ECO Aviation Fuel Services Limited

PERMANENT AVIATION FUEL FACILITY

DESIGN AUDIT REPORT

Report Title: Design Audit on PAFF**Date: January 2010**

(20) Containment for leak detection of the bottom of storage tank 15-Jul-2009

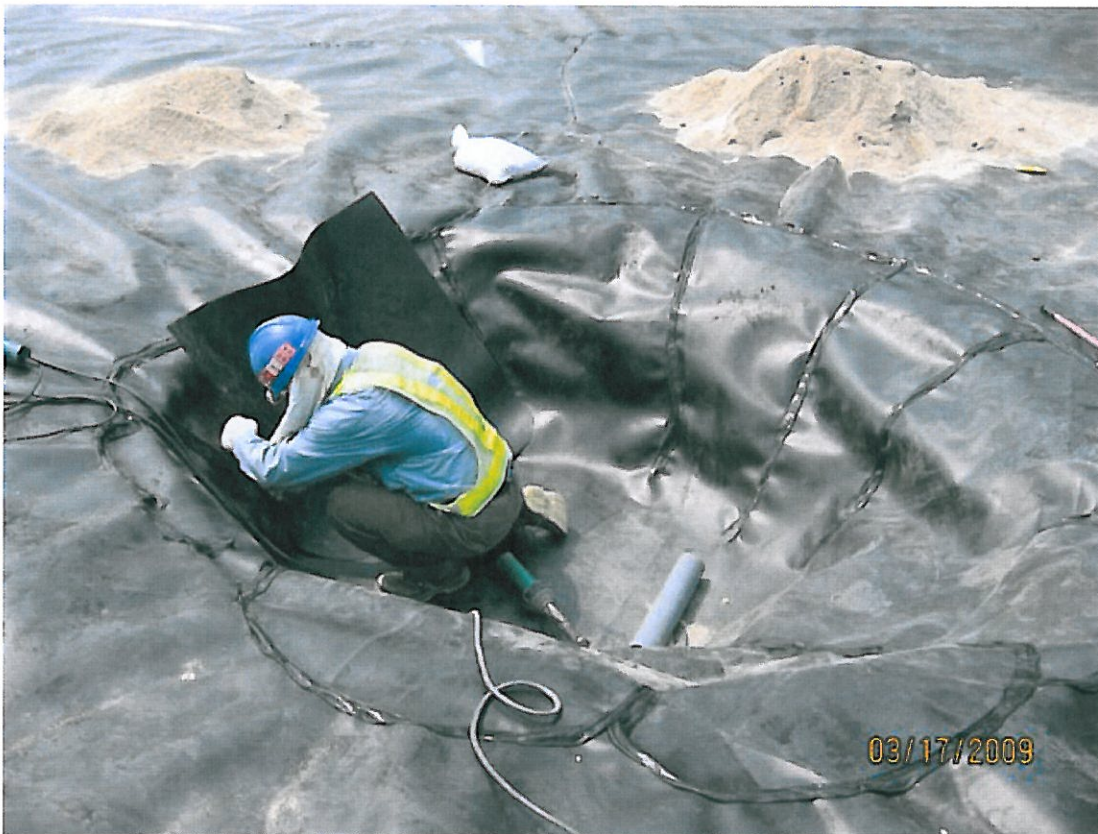
C.3 Impermeable lining leakage detection system shall be properly designed and constructed for the Project.

<p>Drawing PAFF/BA/02/DWG/C/1705 shows the installation of an 80mm dia. leak detection pipe, in accordance with API 650, underneath the sump of each storage tank. The head of the pipe, which is perforated, is designed to situate above the containment membrane of the tank base and the pipe descending to the end outside the tank ring base. Thus the pipe will collect and drain out fuel, if any, to a designated containment well at the tank side. In this way, any leakage from the bottom of the storage tank can be detected. Also, the bunded areas are laid with impervious membrane to contain any spillage of fuel. See photos No. 20, 21, & 1.</p> <p>The construction of this design has been completed for all tanks.</p>	<p>C</p>
--	-----------------

(24) Tank 17-Mar-2009 Laying membrane in center of tank T12 for sump area

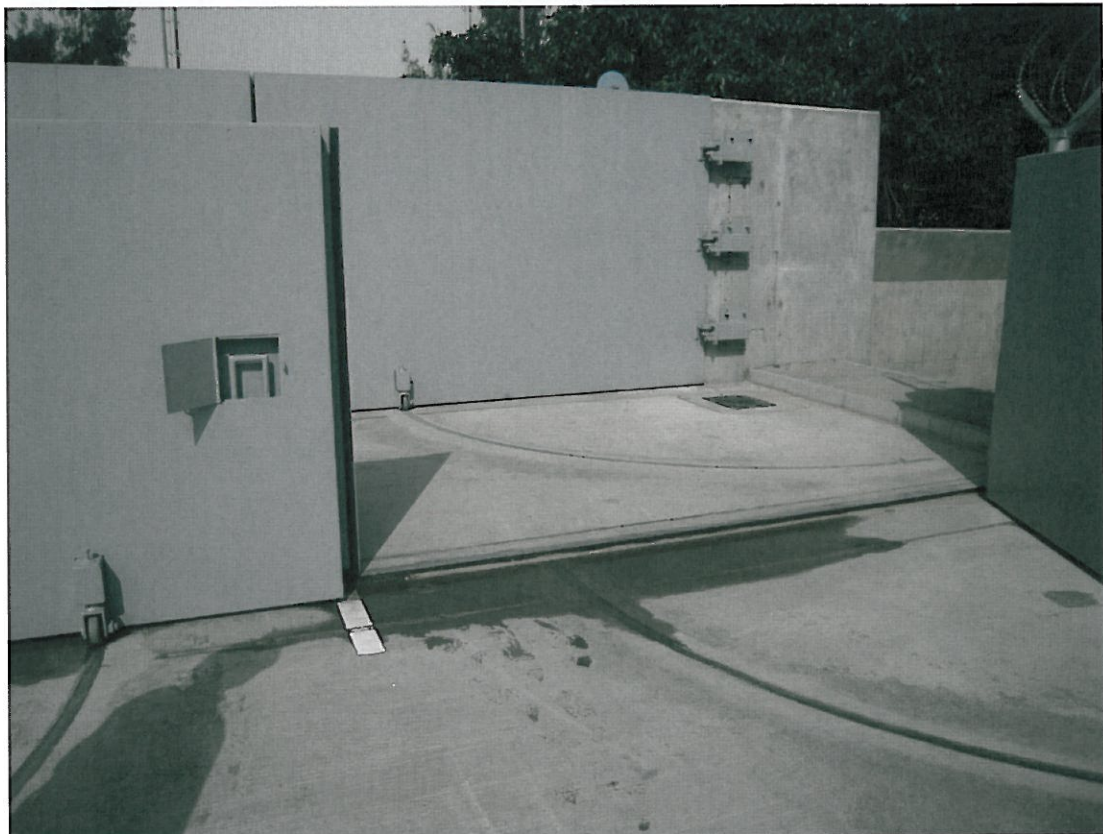
- B.3 Impermeable lining shall be installed underneath all aviation fuel storage tanks to prevent seepage of aviation fuel to ground.

<p>Drawing PAFF/BA/02/DWG/C/1705 shows the installation of impermeable lining (Claymat Containment Membrane) underneath all aviation fuel storage tanks and within the bunded areas to prevent seepage of aviation fuel to the ground due to leakage from the storage tanks. This is meeting the I.P. Code Part 19 “Fire Precautions at Petroleum Refineries and Bulk Storage Installations” item 3.4.2.5.2. See photos No.23 & 24.</p> <p>As the construction of bottom plates for all 8 tanks has been completed, such requirement has been implemented.</p>	<p>C</p>
--	-----------------

Figure 10.6: Location Specific Individual Risk Levels for the PAFF Showing All Identified Scenarios for the Final Development (12 Tanks)

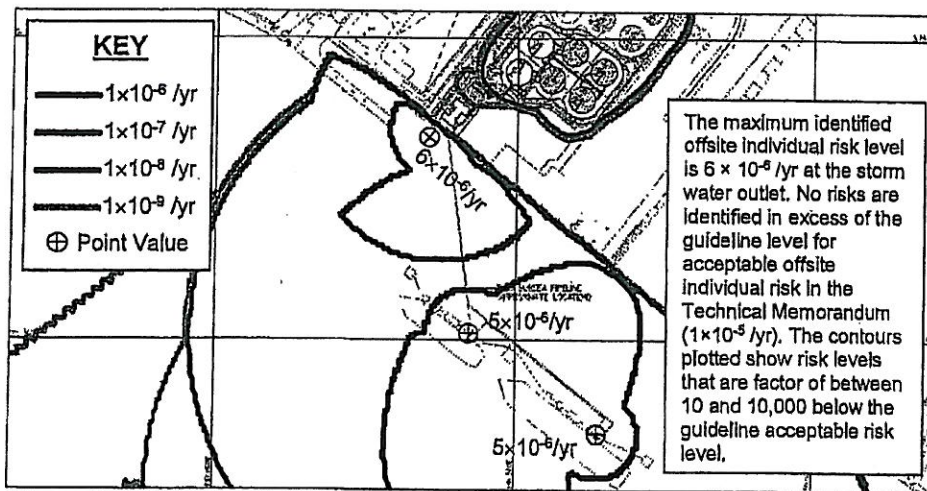
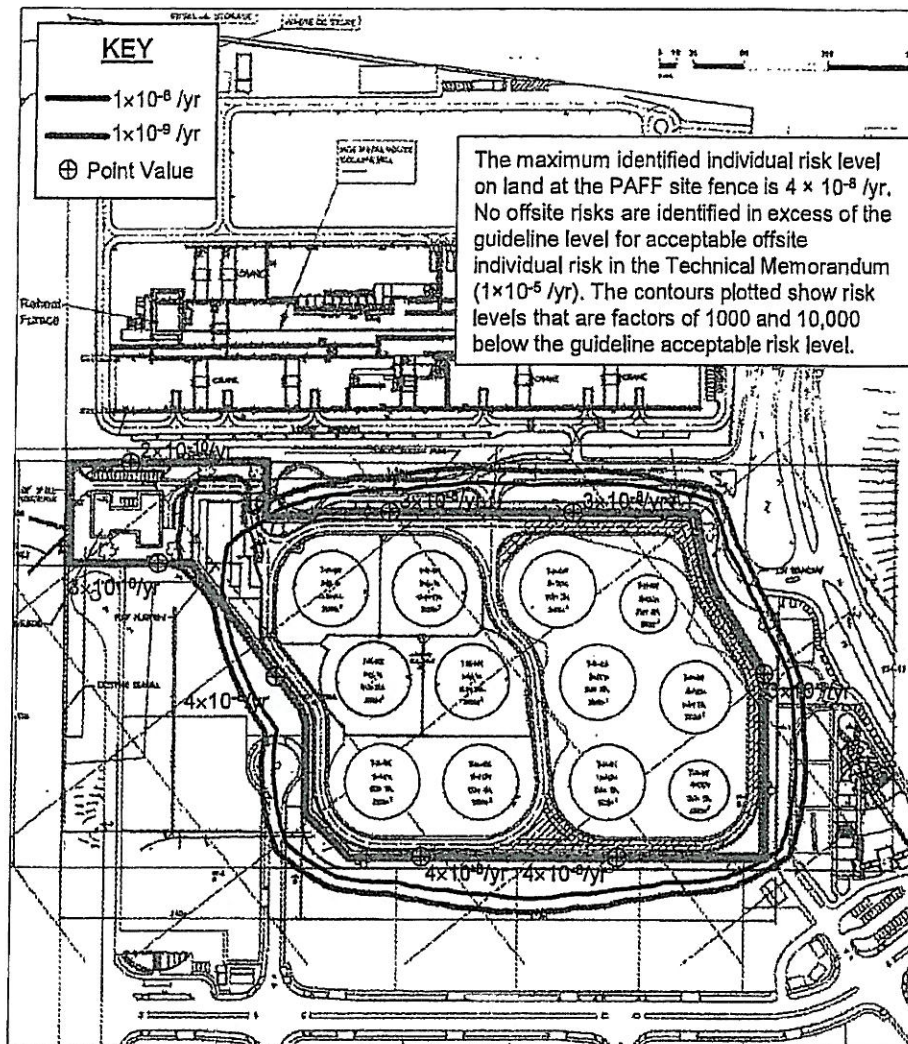
- 7 The onsite and offsite Emergency Plans for PAFF should be developed and tested on a regular basis. Offsite emergency plans including evacuation plans and communication arrangements should be developed in conjunction with the Fire Services Department (FSD), Police, Marine Department and other agencies. Offsite emergency plans for the neighbouring sites will be prepared in order to have an effective evacuation within a short period of time. These will be submitted by the project proponent during detailed design of the facility.

<p>The PAFF emergency plans already cover the evacuation plans and regular drills. The communication arrangement with the authorities and the neighbouring sites are being developed.</p> <p>It is worth mentioning that, as indicated in Figures 10.6 & 10.8 of the EIA Report, although the LSIR is predicted to be finite over the neighbouring sites, SWS mill building and Phase I of the Eco Park, the risk levels predicted are extremely small.</p> <p>Copies of Figures 10.6 & 10.8 of the EIA Report are attached in Appendix 4.</p>	<p>C</p>
--	-----------------
